## 1000 - 1500 SERIES

<b>Part Numbers Affected:</b>	<b>618-05010, 918-05010, 618-05100, 918-05100.</b>
<b>Models Affected:</b>	<b>13xx93xxxxx (LTX and LGT Models).</b> (Models that begin with <b>13</b> and have <b>93</b> in the 5th and 6th position).
<b>Serial Number Range Affected:</b>	Model Year 2013 and 2014 (1A033H3xxxx through 1F054H3xxxx).
<b>Date:</b>	July 17, 2014/September 15, 2015 <b>Revised June 22, 2016 (Destroy All Previous Copies).</b>
<b>Subject:</b>	<b><u>Tuff Torq K46 Hydrostatic Transmission Axle Seal Oil Leak</u></b>

**FIGURE 1**

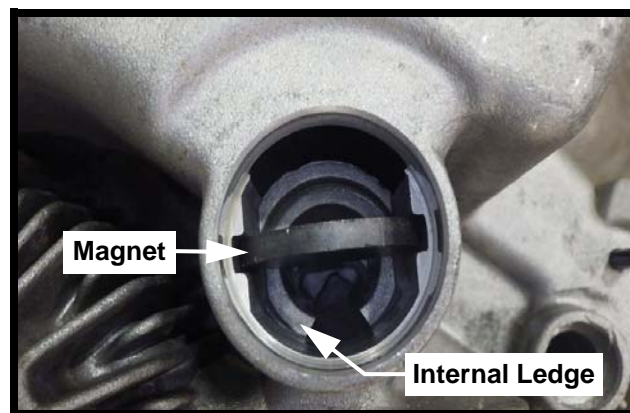
**NOTE:** Oil level should be to the height of the internal ledge feature located below the magnet shown in Figure 1.

**FIGURE 2**

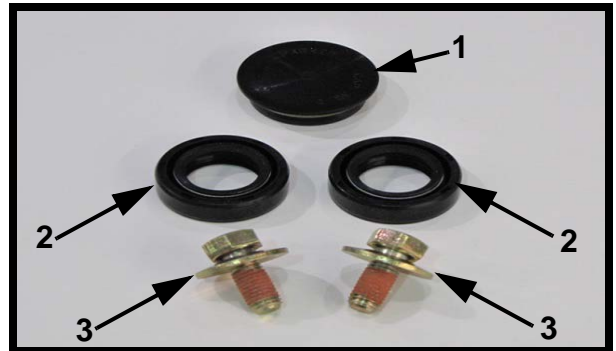
7. From your parts source, order Service Kit **753-08294A**. Figure 2 below shows contents of Service Kit.
